South Texas Project
Units 3 and 4
Docket Nos. 52-012 and 52-013
Supplemental Response to Request for Additional Information

RAI 03.07.01-27, Supplement 3**QUESTION:****Follow-up Question to RAI 03.07.01-19 (STP-NRC-100093)**

RAI 03.08.04-30 Supplement 2**QUESTION:****Follow-up to Question 03.08.04-23**

Figure 3H.6-226: SSI, SSSI, ASCE 4-98 and Design Lateral Seismic Soil Pressures on Diesel Generator Fuel Oil Storage Vault No. 1B North Wall

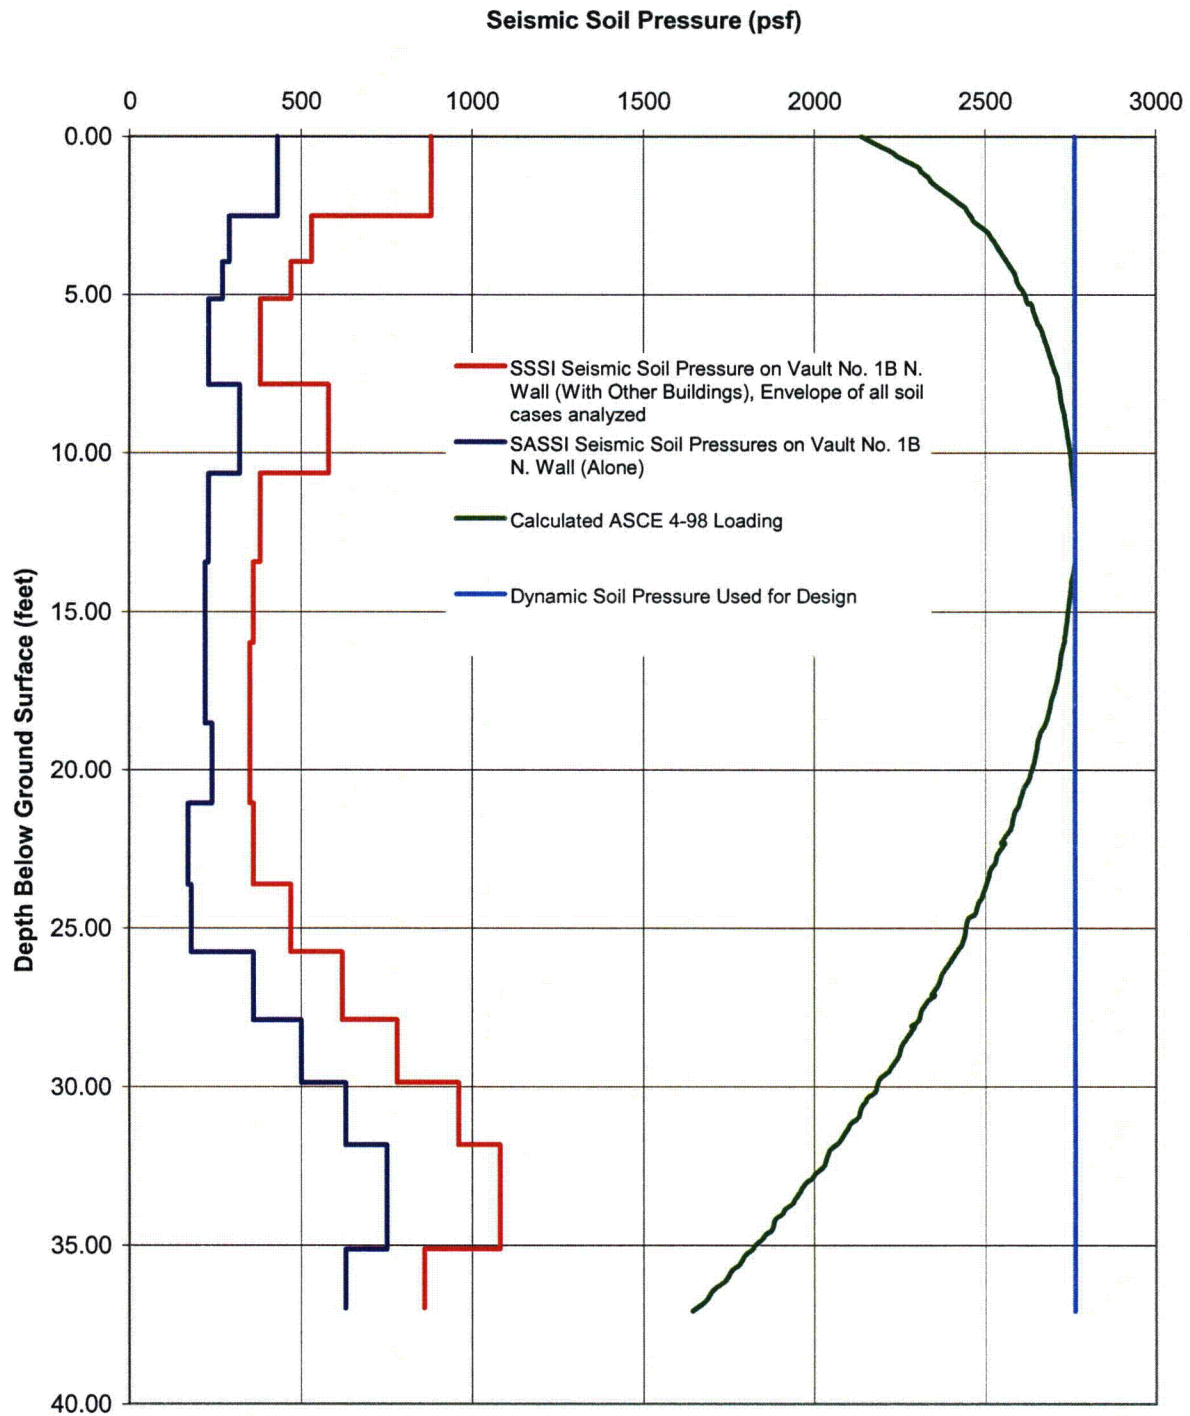
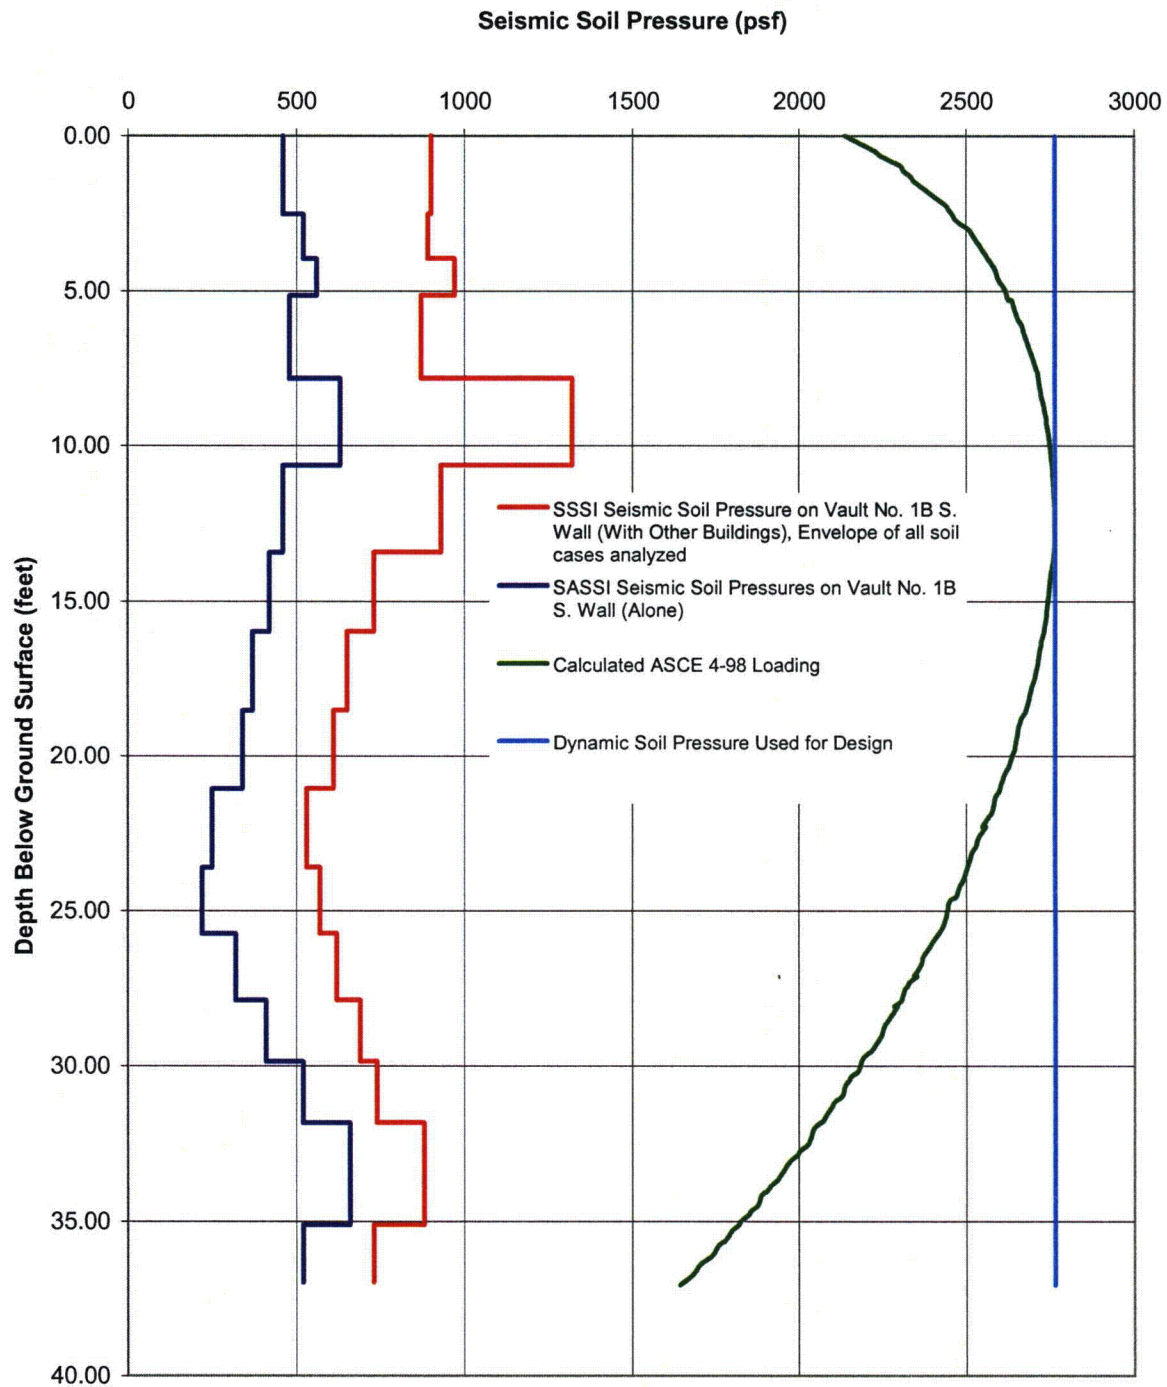
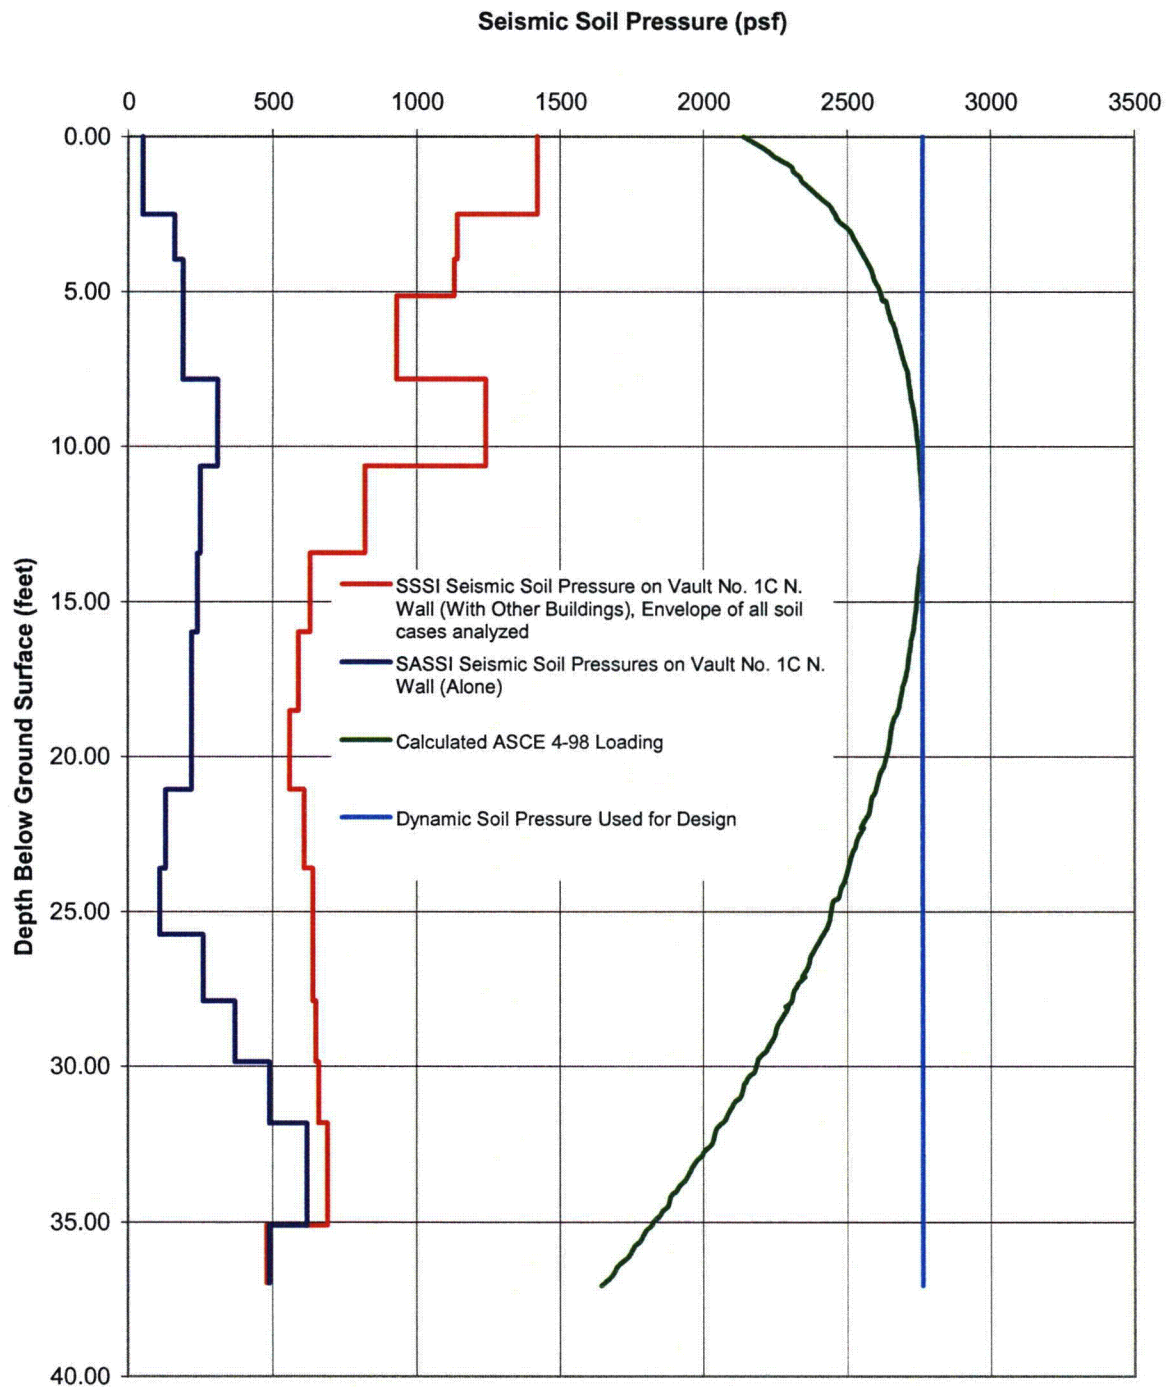
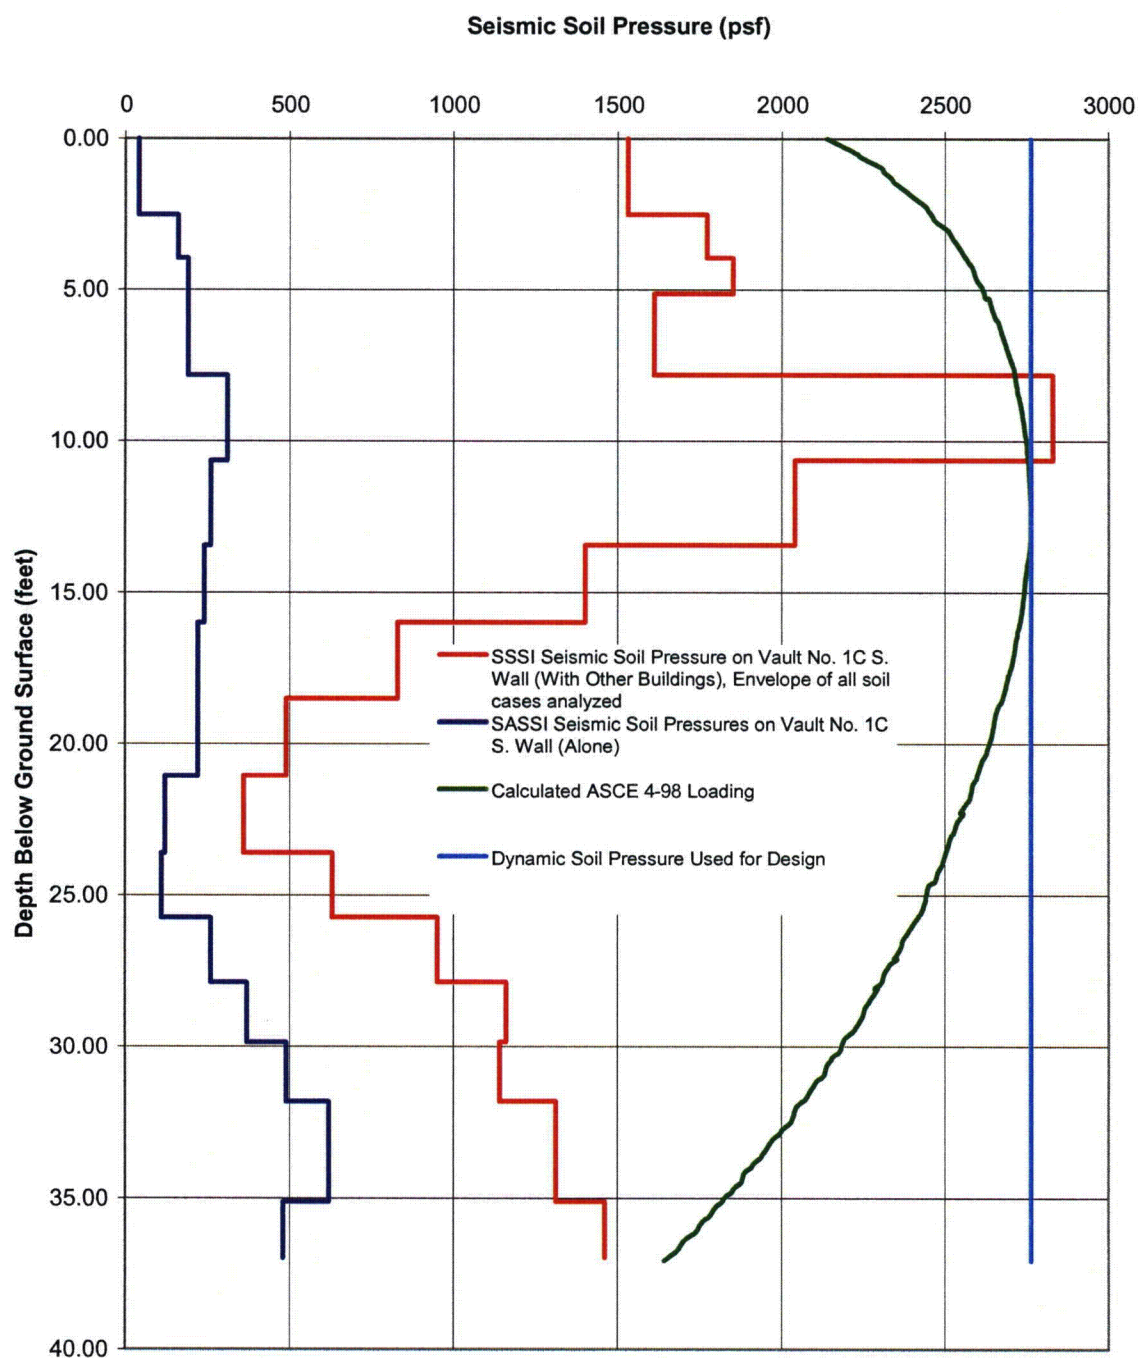
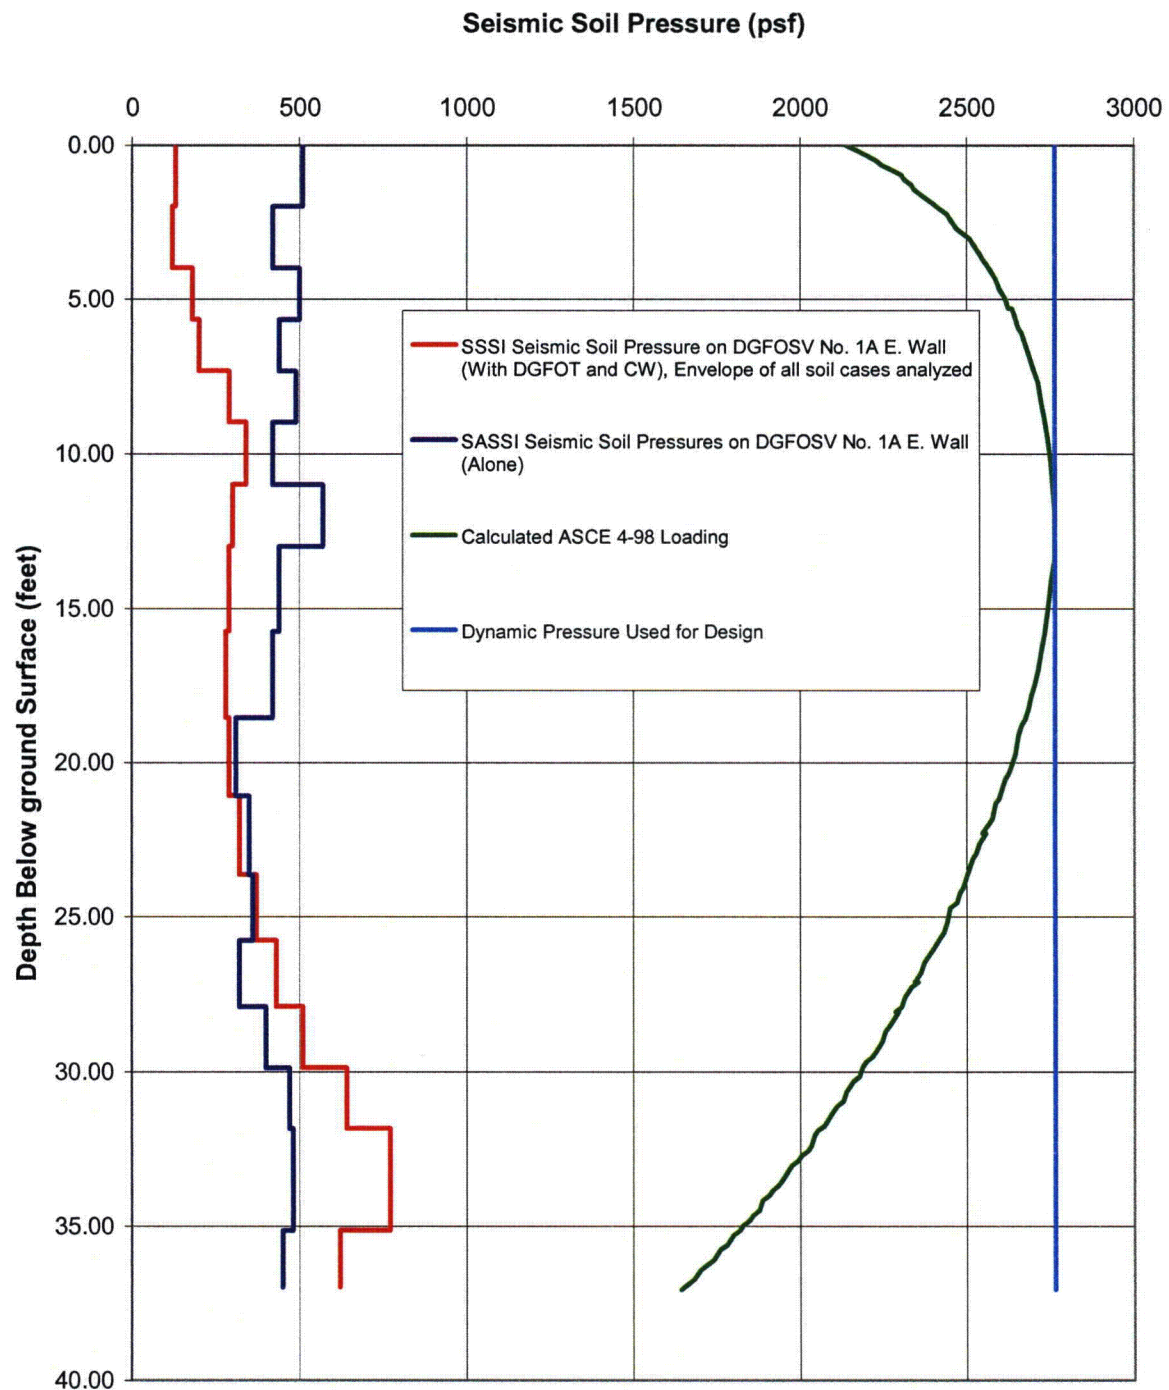
Review of responses to RAI 03.07.01-27, Supplements 1, Revision 1 indicates that two 2D SSSI models (East-West and North-South Sections) are analyzed to evaluate the effects of nearby structures on the three DGFOVSs and calculate the seismic soil pressures. In the East-West direction 2-D SSSI DGFOVS model (DGFOT 1C + DGFOVS 1A + CFRW), five cases of soil and backfill properties are considered to evaluate the effects of the soil and backfill properties variation. Also response to RAI 03.07.01-27, Supplement 2, Revision 2 indicates that in the East-West direction for DGFOT 1A (RB + DGFOT 1A + CFRW), five cases are run with various combinations of soil and backfill properties. However, in the North-South direction (UHS/RSWPH + RSW Tunnel + DGFOVS 1B + DGFOVS 1C + RB), only one case was run with UB soil properties. Also as discussed in response to RAI 03.07.02-24, Supplement 1, Revision 1, in the East-West direction for dynamic soil pressure evaluation for RSW Tunnel and RWB walls, the 2 D SSSI model (RB + RSW Tunnel + RWB) included only the UB in situ soil without any evaluation for backfill properties. As such, the applicant is requested to demonstrate that consideration of only UB soil profile instead of using a combination of UB soil and backfill parameters for the cited cases will still be conservative for the wall design of all site specific Category I and RWB structures (UHS/RSWPH, DGFOVS, RSW Tunnel, UHS/and RWB). The applicant is also requested to include this evaluation in the applicable sections of the FSAR.

The following revised COLA figures showing SSSI soil pressures, based on envelope of all soil cases analyzed, are provided in the Enclosure.

Control Building:	Figure 3A-302
Reactor Building:	Figures 3A-301, and 3H.1-1 through 3H.1-6
Radwaste Building:	Figures 3H.3-50 and 3H.3-51
RSW Piping Tunnel:	Figures 3H.6-212 through 3H.6-217
UHS/RSW Pump House:	Figures 3H.6-218 through 3H.6-220
DGFOSV:	Figures 3H.6-226 through 3H.6-231
DGFOT:	Figures 3H.7-5 through 3H.7-8
